## **DETAILED ACTION**

Art Unit: 3676

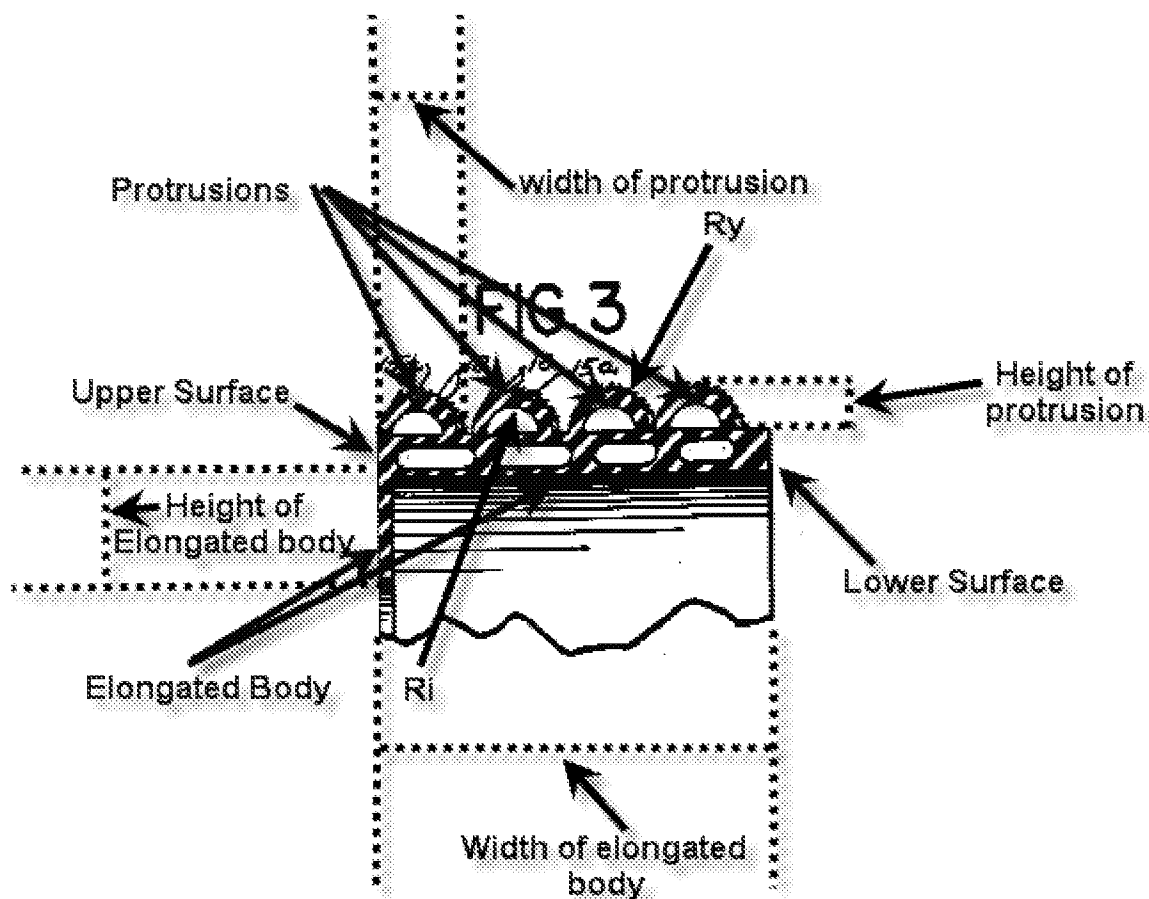
Regarding claims 4-9 and 13-19: Each of the protrusion has an upper delimitation surface and a lower delimitation surface (e.g. upper surface of 15 which adjacent to the upper surface of the elongated body) and projections of the upper and lower delimitation surface of the protrusions in parallel width of the elongated body are located between the upper surface and lower surfaces of the elongated body (e.g. the protrusion are between the upper surface and

lower surface of the elongated body). The protrusion each exhibit an extension in height-direction which is smaller than the extension in height of the elongated body (e.g. see figure below).

Surface perpendiculars of the upper, lower, and lateral surfaces of the elongated body each extend in a continuous or non-changing direction, whereas the surface perpendicular of an outer side surface of each of the protrusions facing away from the elongated body, changes direction with position along the length of the protrusion so that the scalar product of the outer side surface perpendicular and a vector oriented along the longitudinal direction of the elongated body in the vicinity of a given protrusion changes sign on from one end of the protrusion to the other (e.g. this is the case since the protrusion have a structure that is semi-circular).

Each of the protrusions exhibits an outer side surface facing away from the elongated body and an inner side surface facing towards the elongated body (e.g. surfaces having  $R_y$  and  $R_i$ ), the inner side surface is curved and exhibits a maximum radius of curvature  $R_i$  and the outer side surface is curved and exhibits a maximum radius of curvature  $R_y$  and the maximum radius of curvature of the outer side surface is larger than the maximum radius of curvature of the inner side surface (e.g. this would be the case since the curve on the inner surface forms a smaller circle than the curve on the outer surface).
